**CITY OF LA VISTA
MAYOR AND CITY COUNCIL REPORT
JULY 5, 2023 AGENDA**

Subject:	Type:	Submitted By:
REPLAT & SUBDIVISION AGREEMENT – MAYFAIR 2 ND ADDITION REPLAT EIGHT	◆ RESOLUTIONS (2) ORDINANCE RECEIVE/FILE	CHRISTOPHER SOLBERG DEPUTY COMMUNITY DEVELOPMENT DIRECTOR

Resolutions have been prepared for Council to consider an application by HRC Sagebrook Multifamily, LLC (d.b.a. Hubbell Development Services) for a Replat and Subdivision Agreement for Lot 2 Mayfair 2nd Addition Replat Three, and Lots 1, 2, and 3 Mayfair 2nd Addition Replat Seven to be replatted as Lot 1 Mayfair 2nd Addition Replat Eight. The purpose of the applicant's requests is to allow for the construction of a mixed residential development (multiple-family dwellings) with 264 units.

Exhibit A - Sidewalk Additions

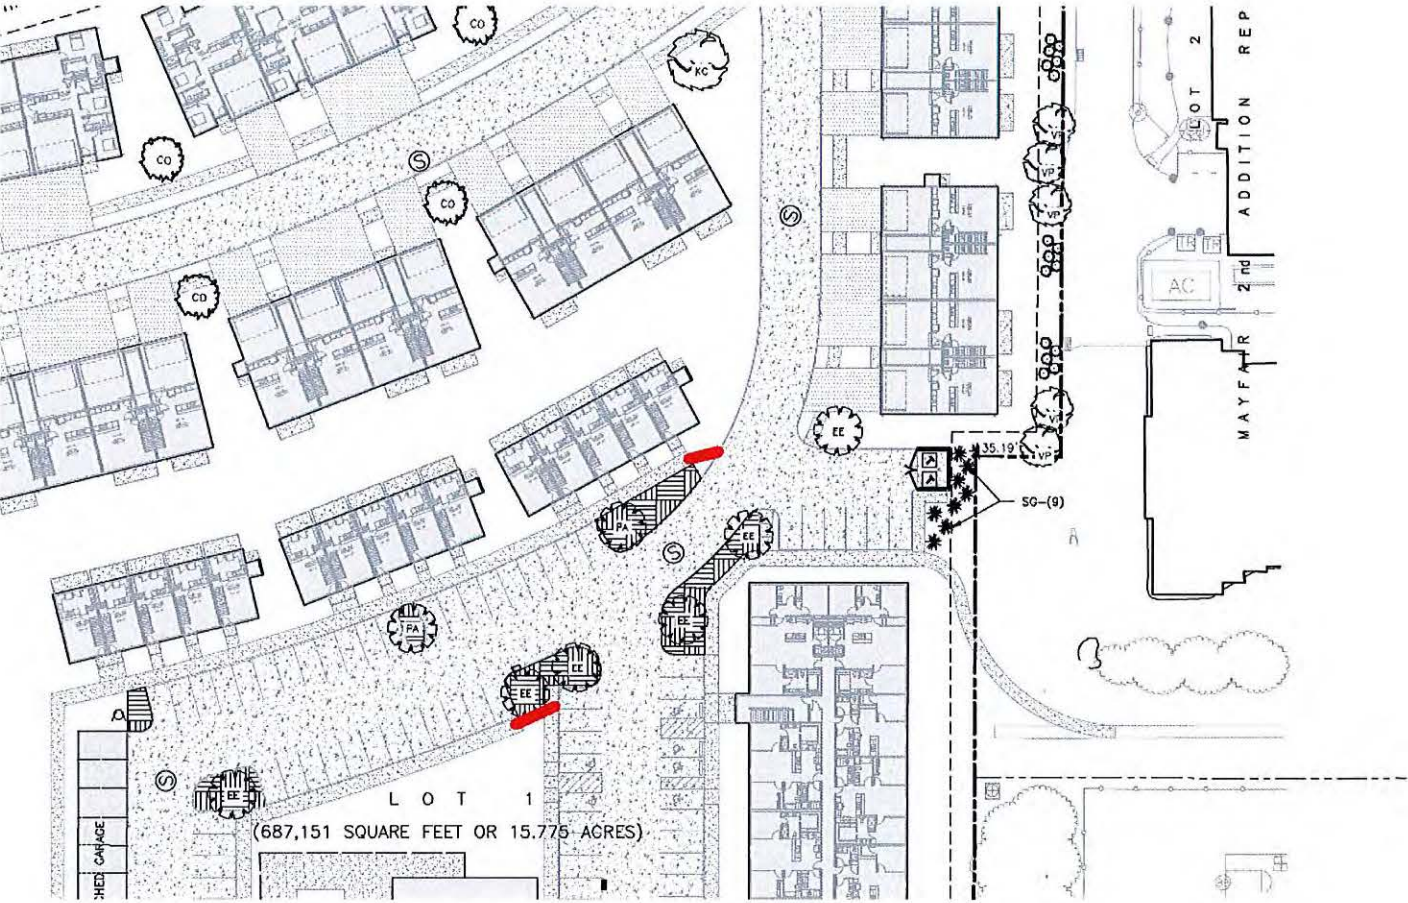
6. Zoning Ordinance Section 5.15.04.07 and 5.15.04.16 – To complete the sidewalk network in the development to provide adequate pedestrian connectivity, please update the plan to include the two sidewalk connections noted in red on the plan in Exhibit A, attached to this letter.

6. Zoning Ordinance Section 5.15.04.07 and 5.1 5.04.1 6 - To complete the sidewalk network in the development to provide adequate pedestrian connectivity, please update the plan to include the two sidewalk connections noted in red on the plan in Exhibit A, attached to this letter.
Sidewalks have been added per Exhibit A.
